GOULBURN RIVER SOLAR FARM

Amendment Report

December 2023

Prepared by
Umwelt (Australia) Pty Limited
on behalf of
Lightsource bp

FIGURE 3.5
Proposed Centralised BESS
Layout

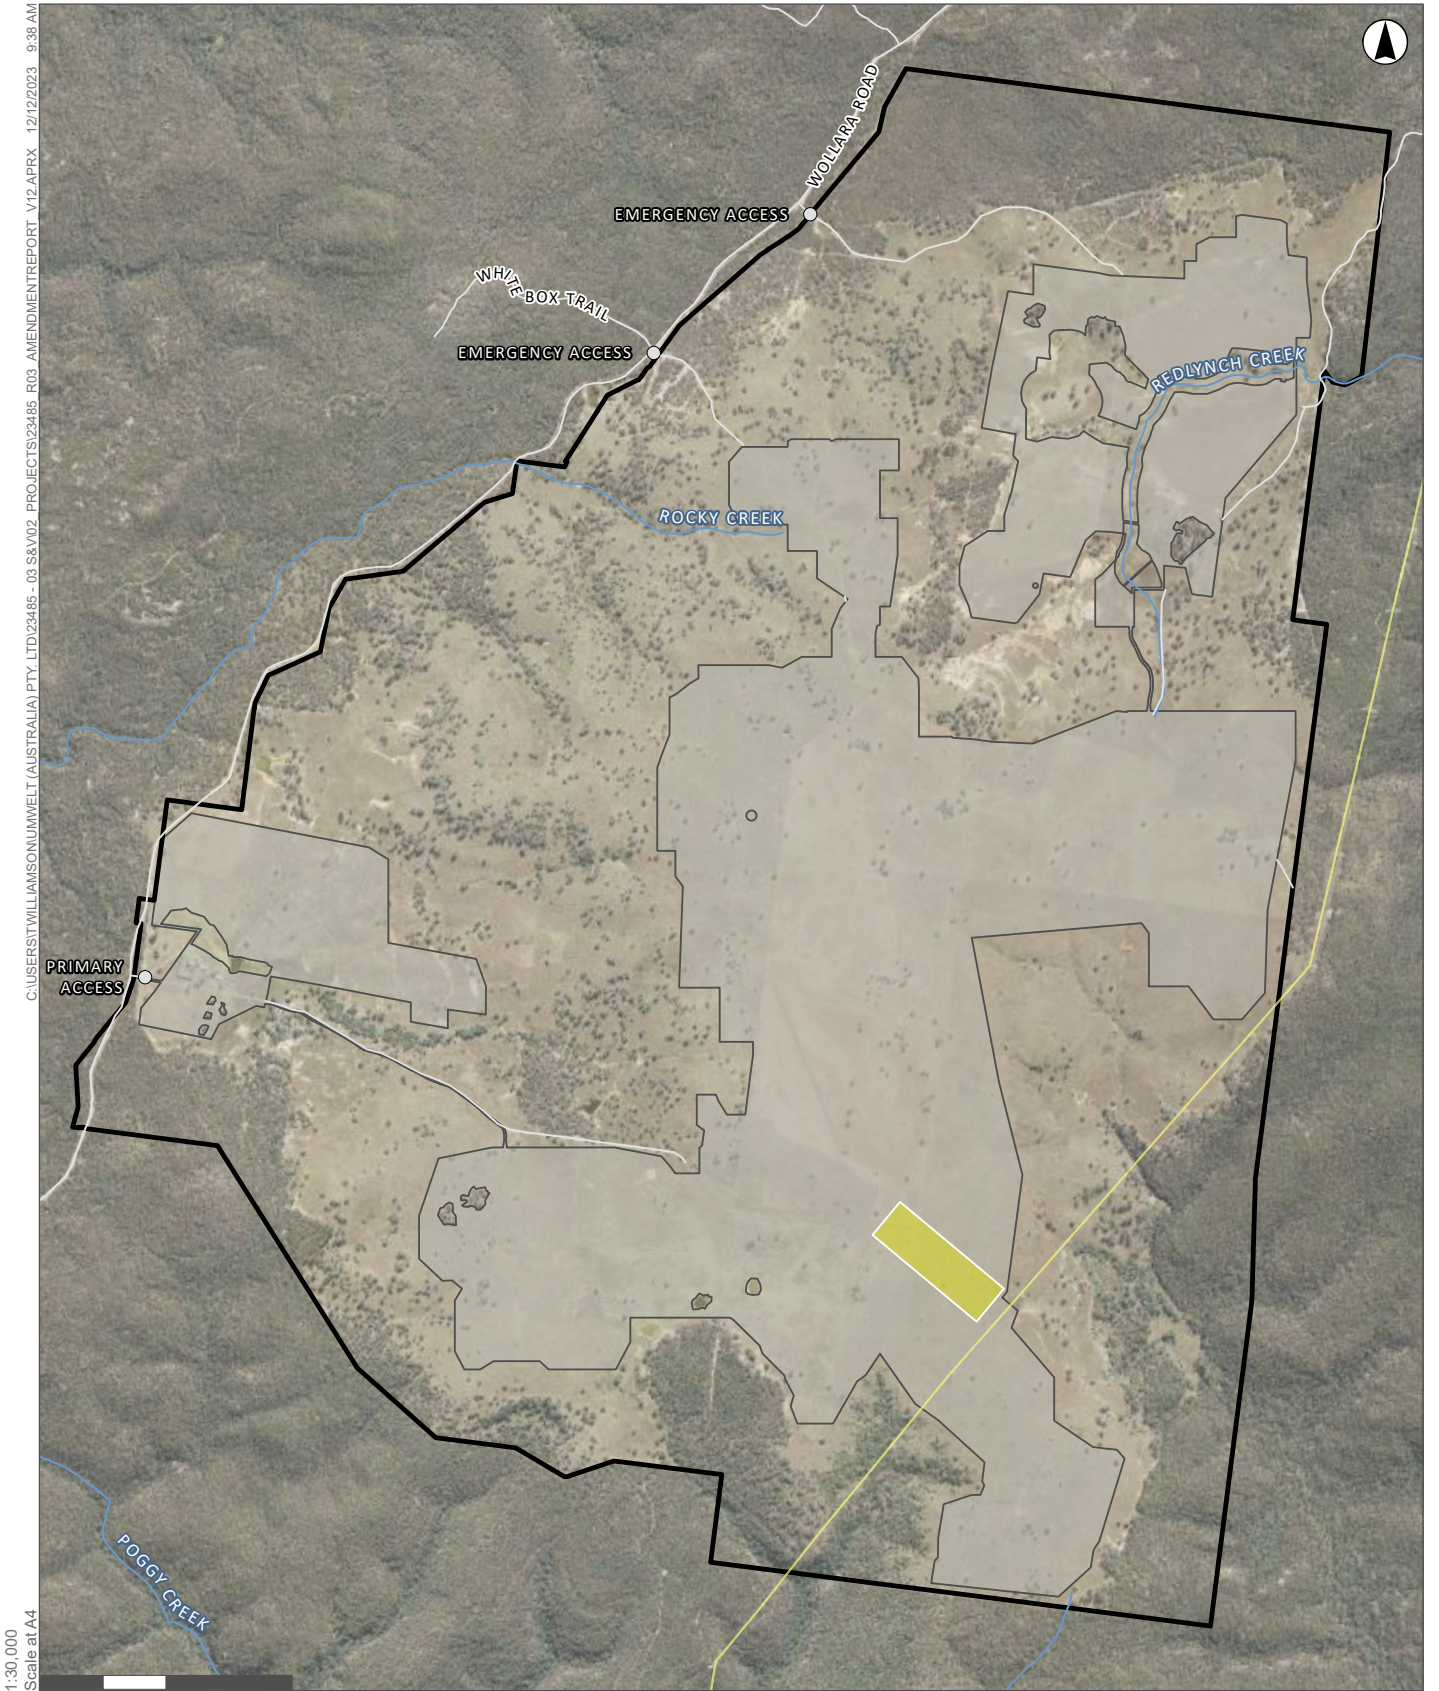
LSbp is also seeking to amend the Project EIS to include the option of a decentralised BESS, to allow for greater flexibility in the design of the final BESS facility. The decentralised BESS option involves 560 individual 6.1 m (i.e., 20 foot) battery containers and DC-DC converters, and associated infrastructure being situated next to the PV inverter stations located throughout the solar arrays, rather than in a centralised location as proposed in the EIS. The layout of the centralised and decentralised options is shown in **Figure 3.4** and **Figure 3.5**.

The conceptual layout of the proposed AC Couple (Centralised) BESS and the proposed DC Coupled (Decentralised) BESS are shown in **Figure 3.4** and **Figure 3.5** respectively. Further detailed conceptual layouts of both the AC Coupled (Centralised) and DC Coupled (Decentralised) BESS units are found in **Appendix H**. The risk control strategies detailed in the *Goulburn River Solar Farm Preliminary Hazard Analysis (2023)* remain applicable to the Amended Project.

FIGURE 3.6
Proposed Decentralised BESS
Layout

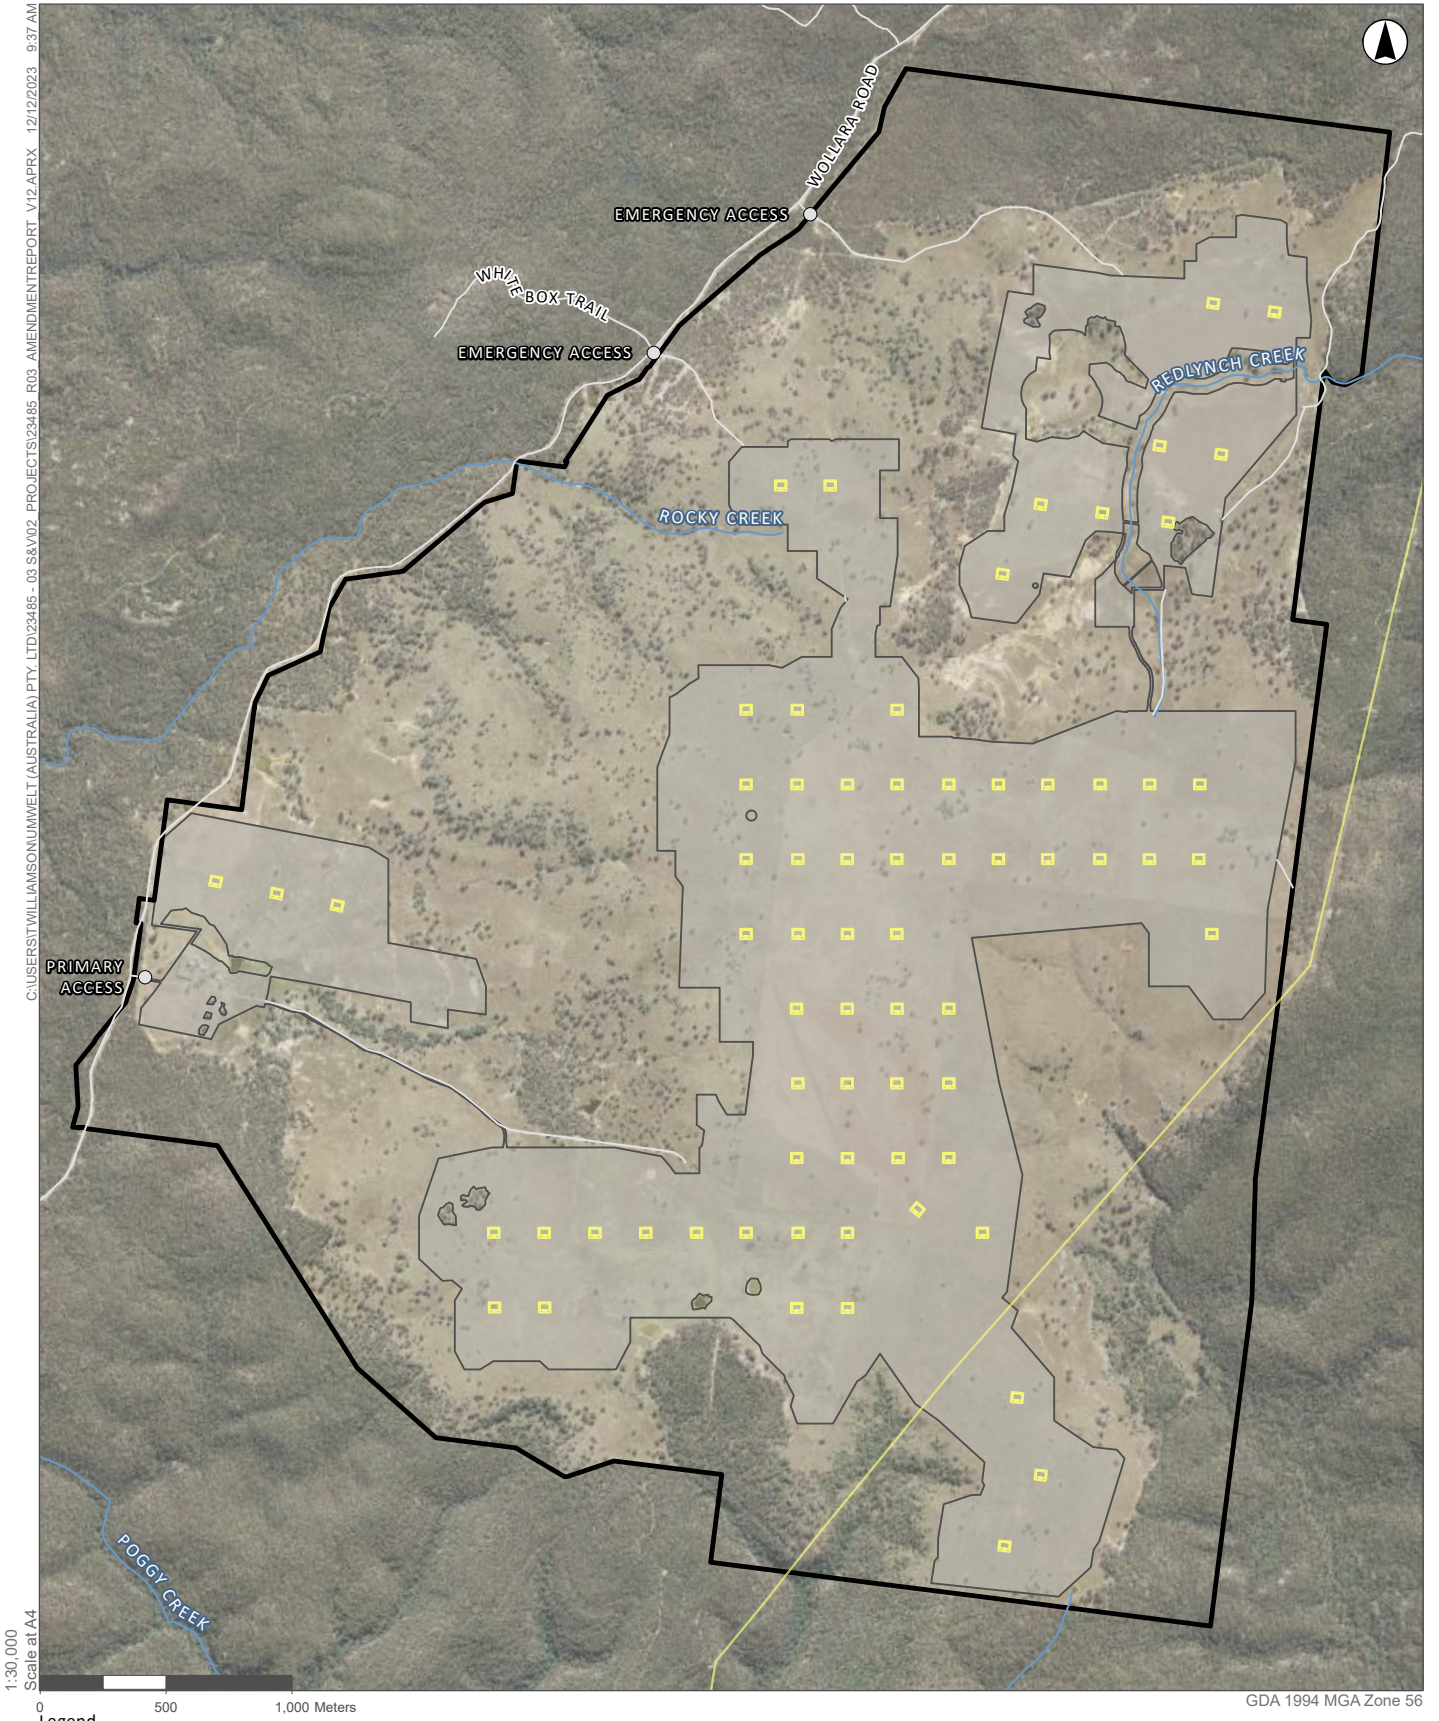
The decentralised system would include a BESS with a capacity of up to 580 MWp/1160 MWh. The decentralised BESS option involves 560 individual 6.1 m (i.e., 20 foot) battery containers and DC-DC converters, and associated infrastructure situated next to the PV inverter stations located throughout the solar arrays. The layout of the centralised and decentralised options is shown in Figure 3.5 and Figure 3.6 respectively of the Amendment Report (copied here in **Appendix 1**).
